# Roadway Plans\_V1.pdf Markup Summary

# CONSTRUCTION PLANS

CLEARWAY FILING NO. 2, LOT 5		TITLE SHEET	
PROJECT NO. 44-042A		DATE: 06-02-2022	
DESIGNED BY: DIM		SCALE: HORIZONTAL: N/A	
DRAWN BY: CLP		VERTICAL: N/A	
CHECKED BY: DIM		SHEET 1 OF 15	
TS01

**CURB INLET TYPE R STANDARD PLAN NO. M-604-12**  
 Sheet No. 2 of 2

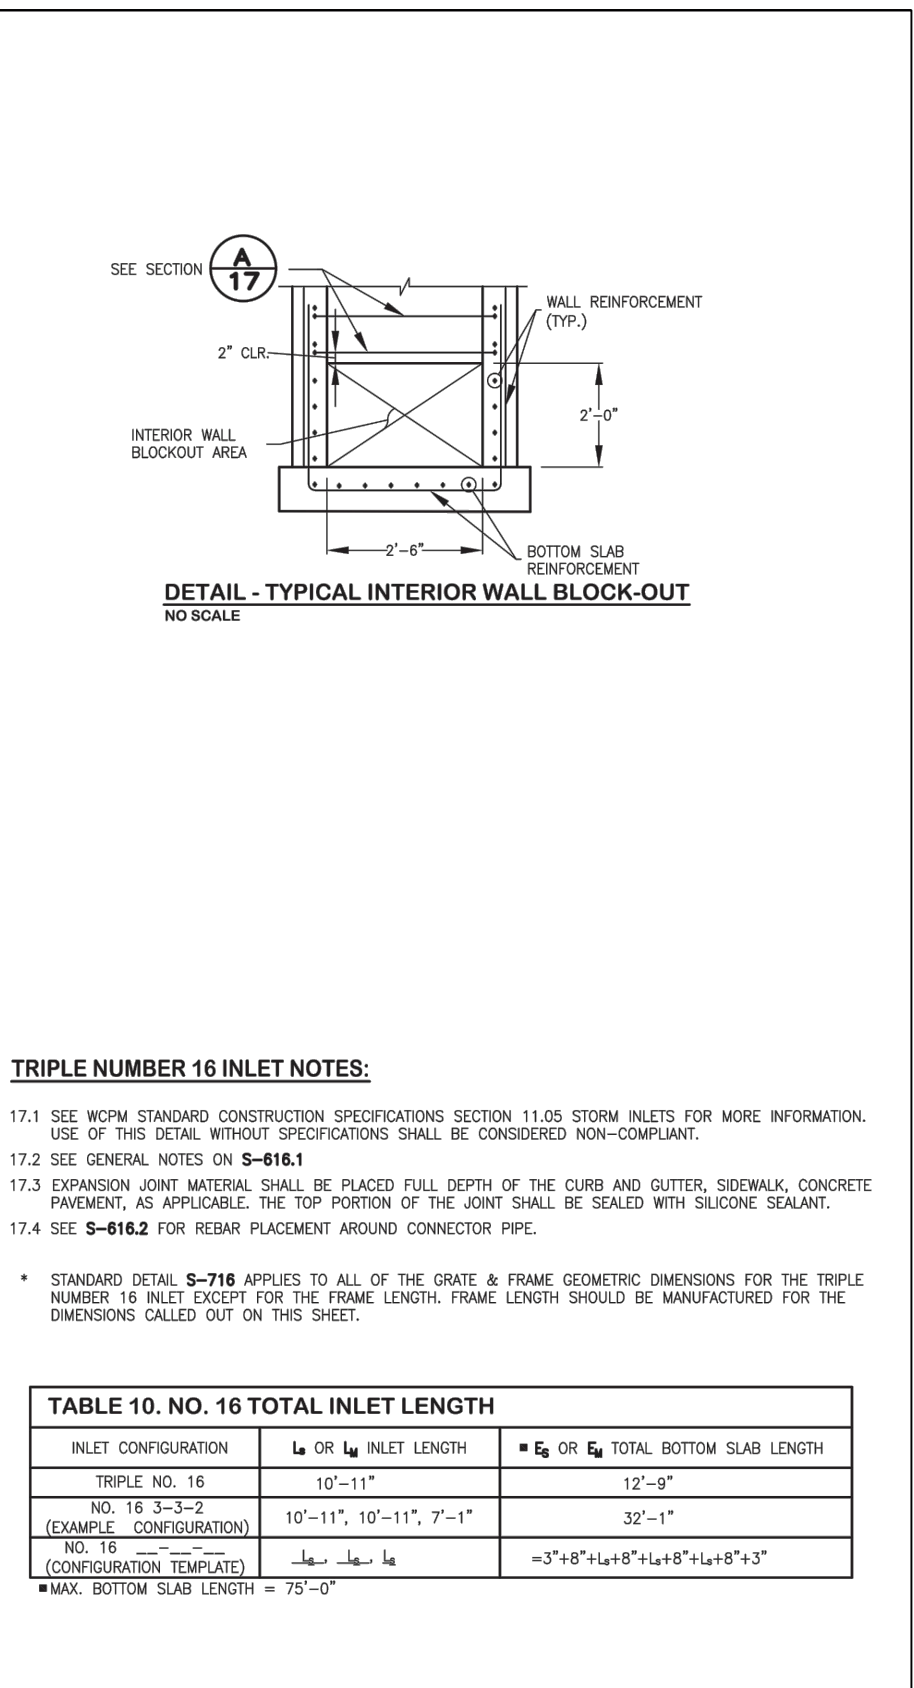
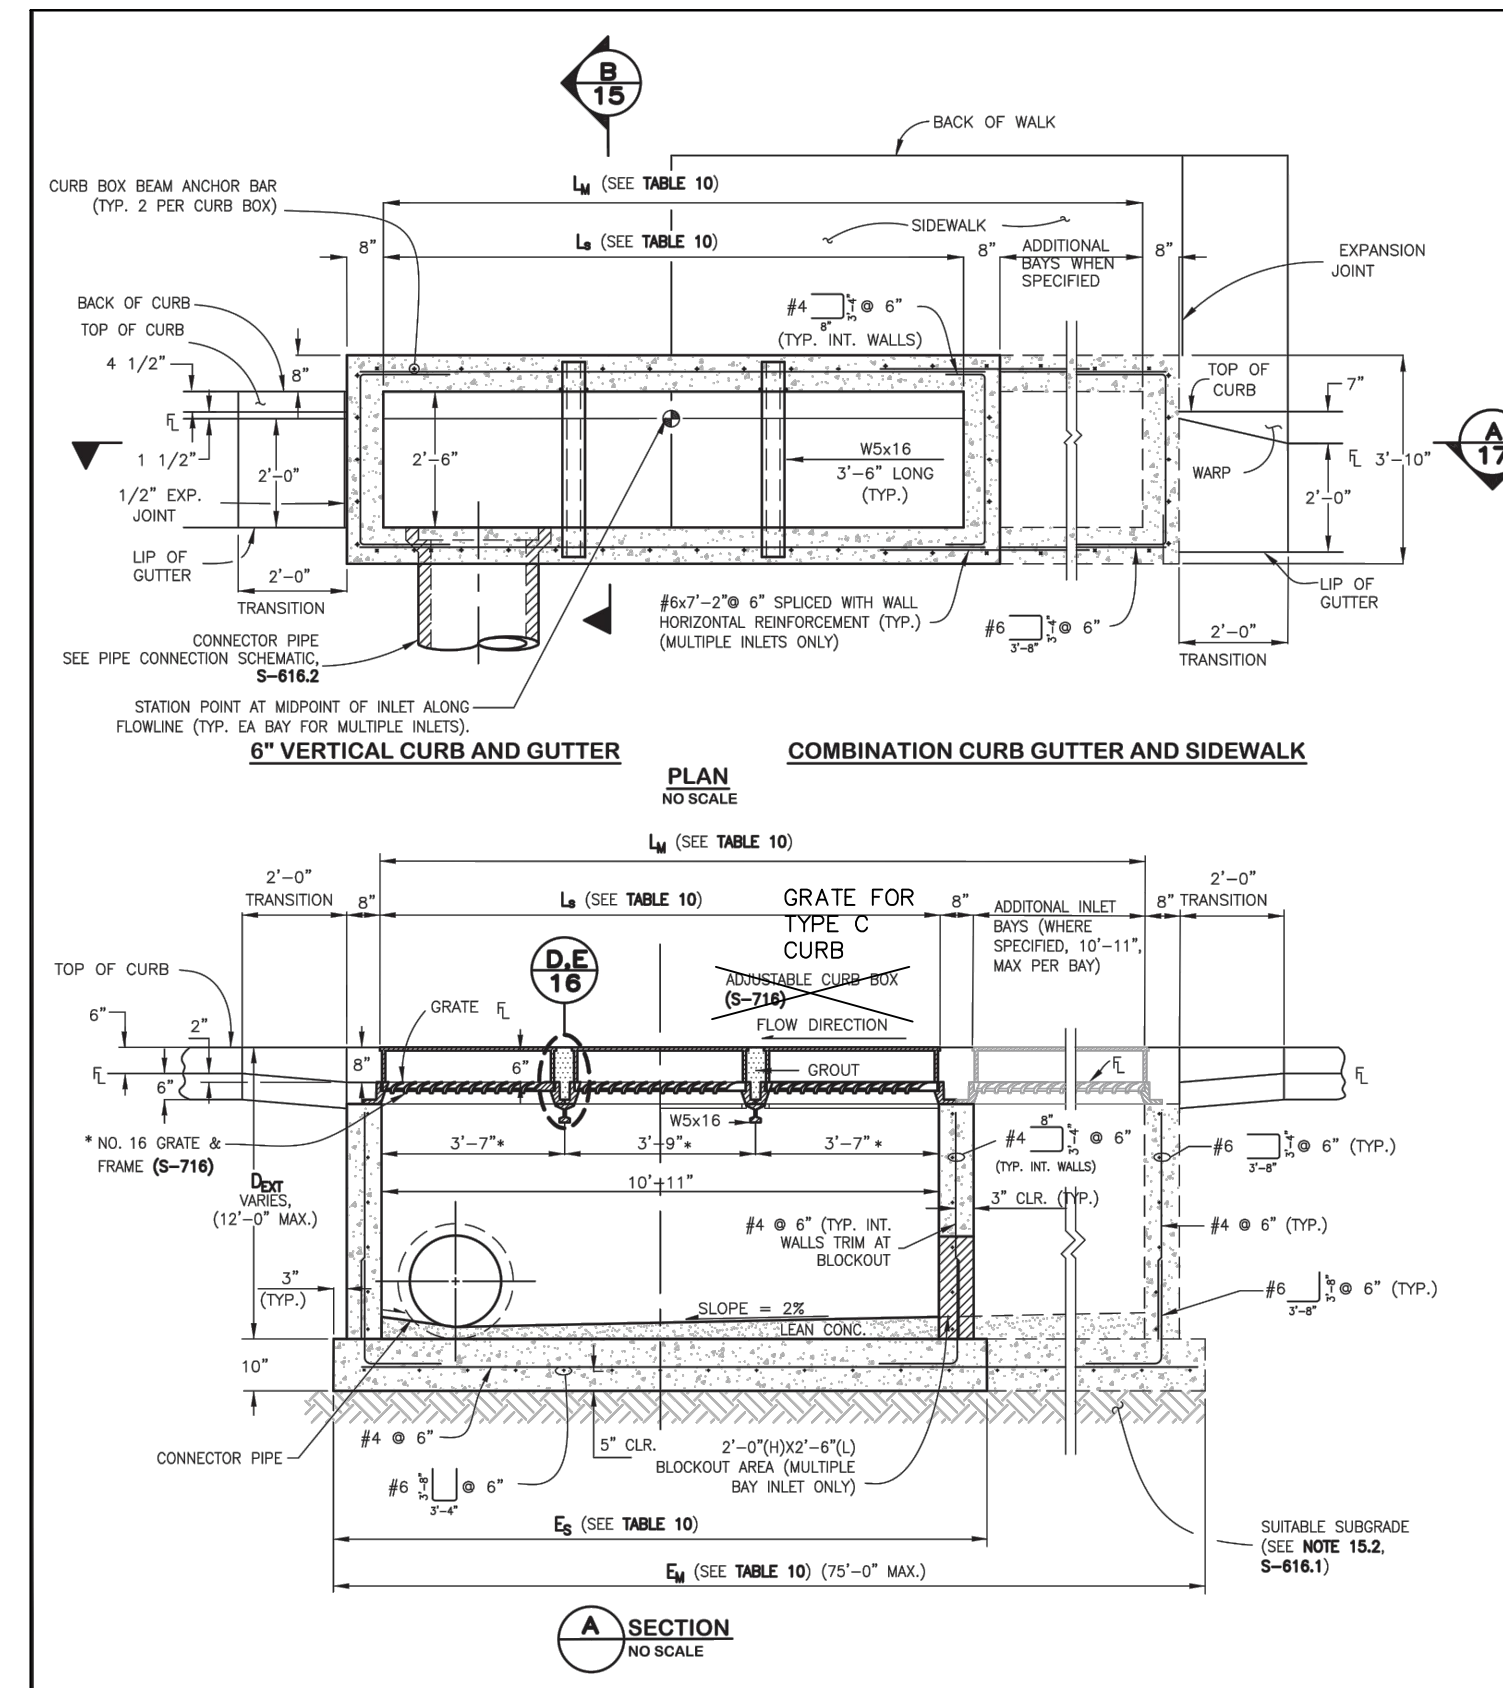
update file no.
